Field Remedy: 1467

Subject: **Rear Lamps - Water ingress**

Speedster 2000...2002 Z22SE

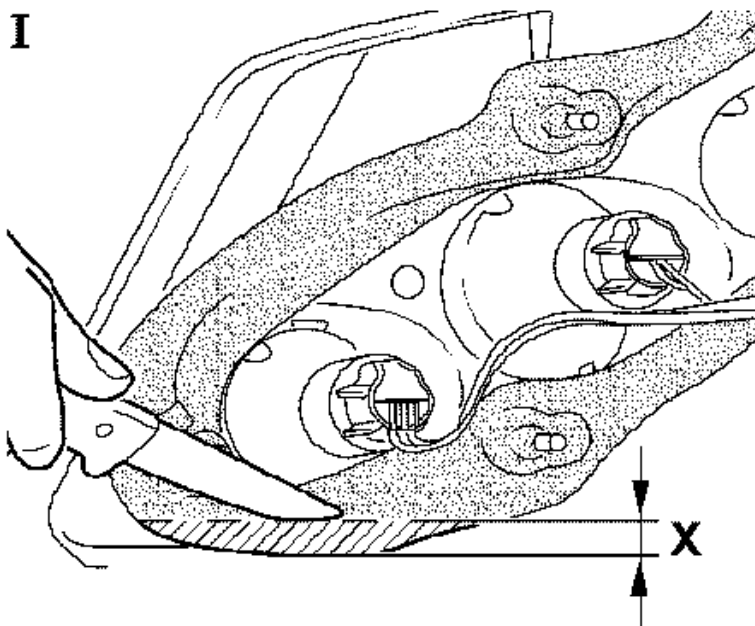
Complaint: Water ingress on rear lamps.

Cause: Poor position of sealing rear light.

In case of customer complaint cut and remove a foam rubber section of rear lamps.

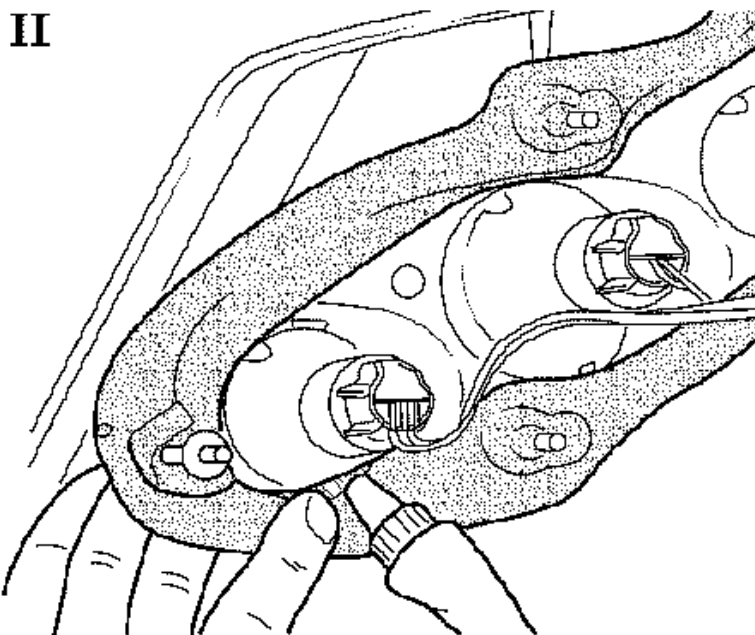
1. Remove rear lamps
 - see working procedure "Rear Lamp, Remove and Install", group "N", Service Instruction Speedster.
2. Cut and remove foam rubber section "x" of rear lamps with suitable tool (picture I, X=20 mm).

3. Is the seal solved by cutting, fix the seal with gluing compound seal (picture II).
